*Mask Set Errata 3*  
**MC9S12D64\* Microcontroller Unit**  
(\*Devices covered: MC9S12D64 and MC9S12DJ64)

This errata provides information applicable to the following MCU mask set devices:

- 2L86D mask

**MC9S12D64MSE3**

**SPURIOUS SYNC PULSE****MUCTS00681**

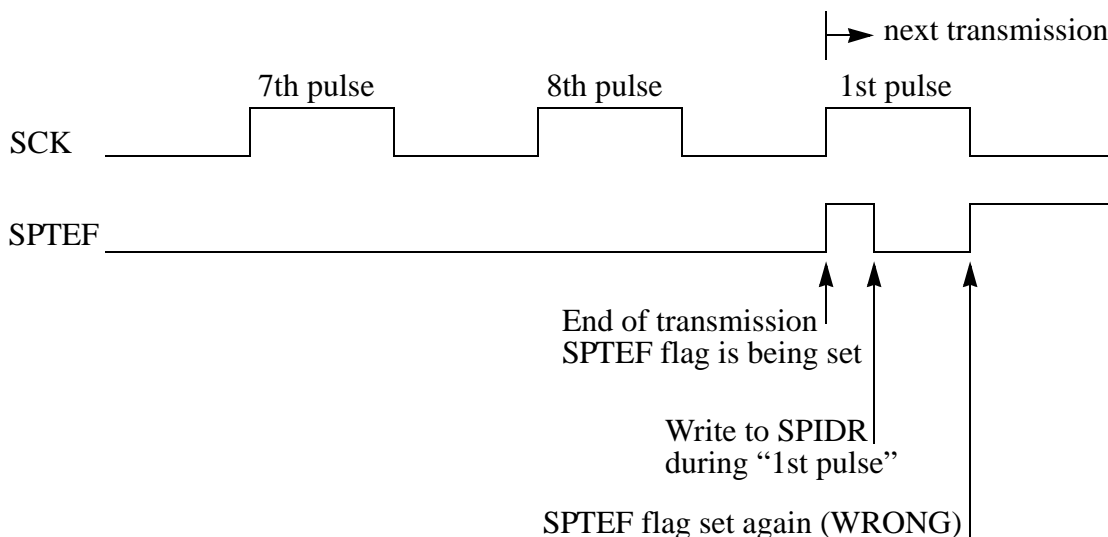
A spurious BDM SYNC pulse could be transmitted if the delay between commands is such that the first negative edge of a new command occurs exactly 128 cycles after the last negative edge of the previous command.

Keep the delay between commands greater than 128 cycles.
